This is to certify that SPURWINK SCHOOL /TBAhas permission to Residential Change of Use - Reconvert part of the First Floor into Handicapped Family Units. 2009AT 17 BISHOP STCity of Portland
CL 293 A016001

Permit No: 09-0183	Issue Date:	CBL: 293 A016001
-----------------------	-------------	---------------------

Dept: Zoning **Status:** Approved with Conditions **Reviewer:** Marge Schmuckal **Approval Date:** 03/11/2009

Design No. U499
Assembly Rating — 1 H
Nonbearing Wall Rating — 1 Hr.

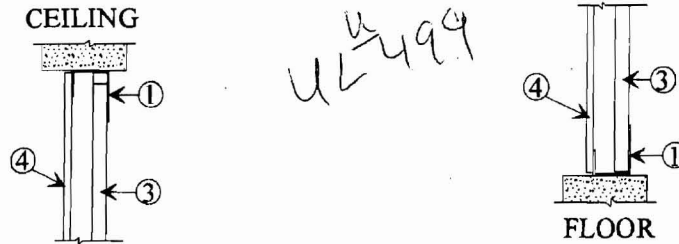
3/23/2009-jmb: Spoke with Mike C. For details on separation of dwelling units, UL listing on shaft and fire partions and common corridor/lobby # 102 rating. Also verified that notes N07 & N08 should be switched. This is a mixed nonseparated use, but the dwelling unit and common corridor need to be separated per Sec. 708 and Table 1016.1, with opening protective of 20 min. Per table 715.3. He will email sketches.

The shaftwall assembly indicated on the second floor plan and in detail 5/A7 has a one-hour rating, and is equivalent to UL assembly U499. The through-penetration firestop is equivalent to UL assembly F-C-7002.
